NEW JERSEY  
AGREEMENT STATE APPLICATION  
SECTIONS 4.1 & 4.2

## Roadmap to New Jersey's Agreement State Application

#	APPLICATION SECTION	NRC COMMENT (January 11, 2008 Letter to NJ DEP)	STATE RESPONSE	LEAD
1	Legal Elements Section 4.1.1 Statutory Authority	"Per the Administrative Procedure Act, the State should explain the State's rulemaking process including information on how the state resolves interpretations of State law" ("The explanation should address how the State's rulemaking process accommodates future NRC amendments")	<p>The State's rulemaking process accommodates future NRC amendments through the incorporation by reference provisions that have been incorporated into the rule adoption on all NRC regulations with the exception of Subpart E of 10 CFR 20. This means that when the NRC updates their regulations, the State of New Jersey regulations will automatically be updated to reflect the change. We may, depending on the scope of the rule change, notify the licensees by letter or updates to the Radiation Protection Program website.</p> <p>Adoption published on Sept. 15, 2008 in the New Jersey Register. A courtesy copy of the adopted regulation is provided in section 4.1

AHAOVERVIEW  
APRIL 16, 2007  
OFFICIAL DEP ORGANIZATIONAL CHART

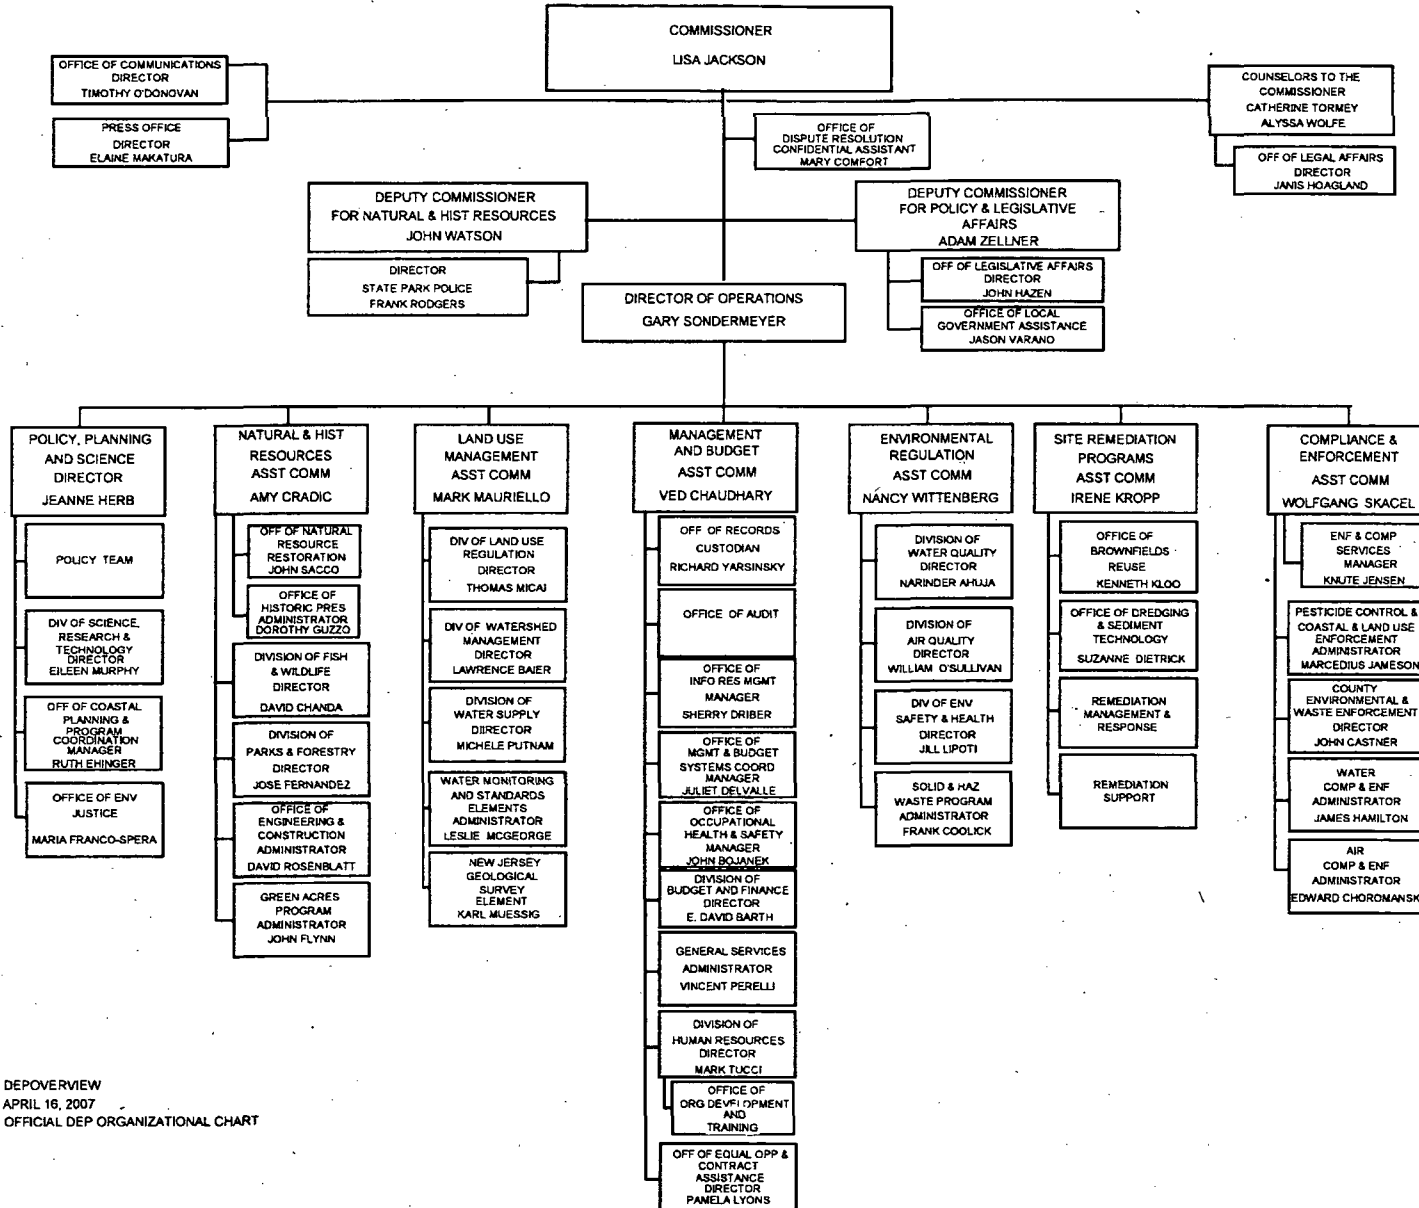
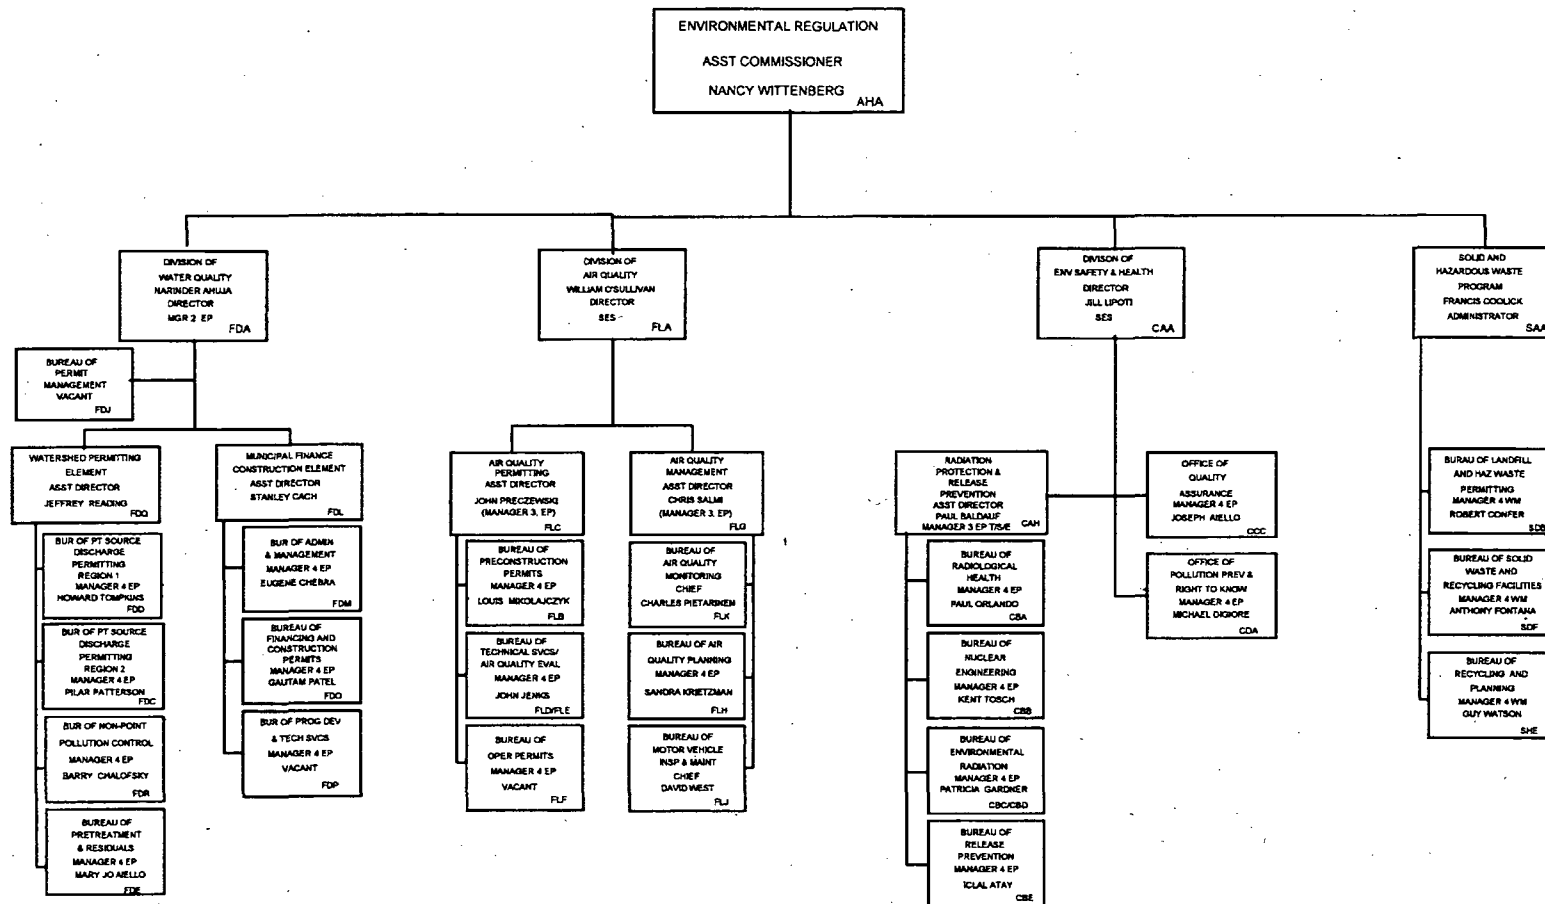
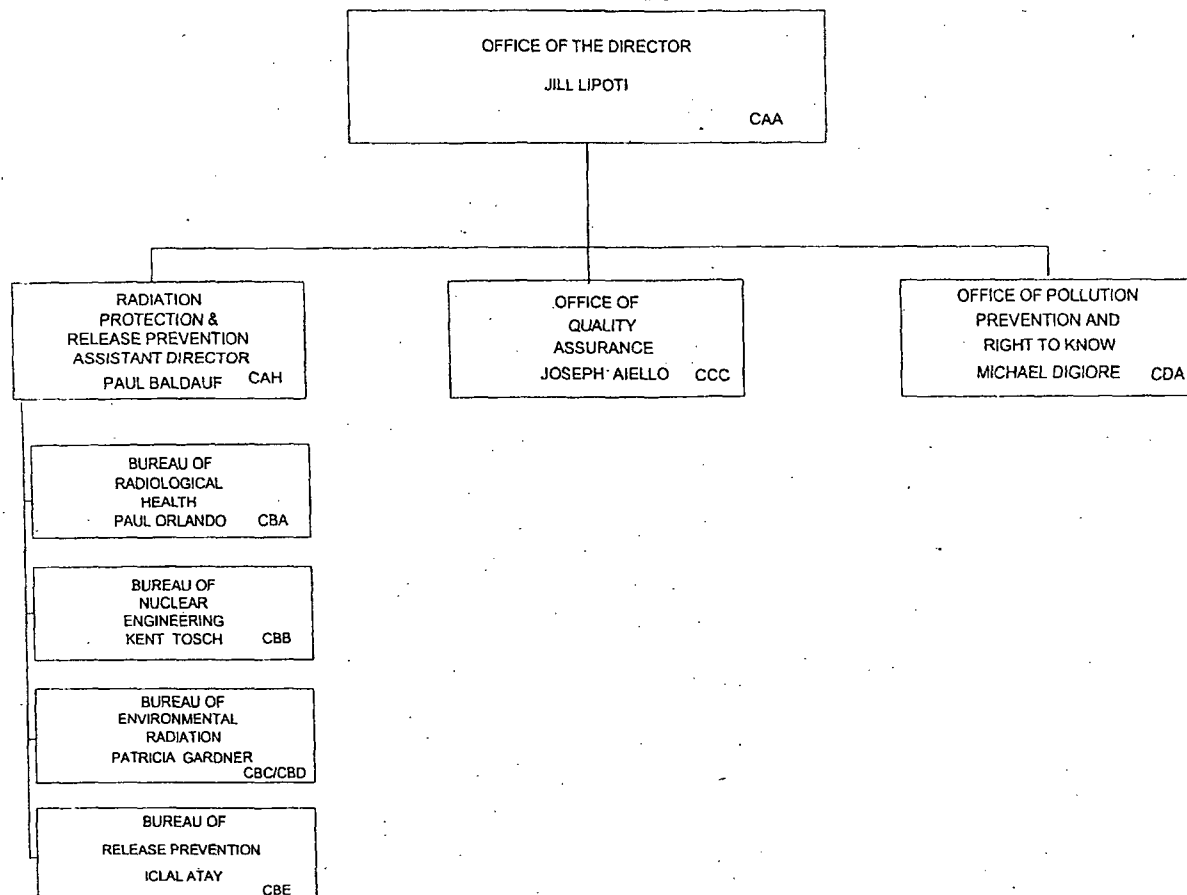
4	Legal Elements Section 4.1.2 Organization of the Proposed New Jersey Program	<p>"The New Jersey organizational charts do not show the link between the Governor and the State program Director"</p> <p>"Please provide information about the linkage in either graphic or text format"</p>	The link between the Governor and the State Program Director is included in the Program Organization document in section 4.1.2.	J. Goodman 6099845498
5	Legal Elements Section 4.1.2 Organization of the Proposed New Jersey Program	<p>"The Bureau of Environmental Radiation description does not identify which organizational unit would be responsible for the low-level waste (LLW) program (licensing, inspection and other actions) if New Jersey is designated as a host State"</p> <p>"Please clarify which organizational unit is responsible for the LLW program"</p>	The Radiological Assessment Section will be responsible for the implementation of the Low Level Radioactive Waste (LLRW) program if New Jersey is designated as a host State in the future. This is now indicated in the Program Overview in section 4.1.2.	J. Goodman 6099845498
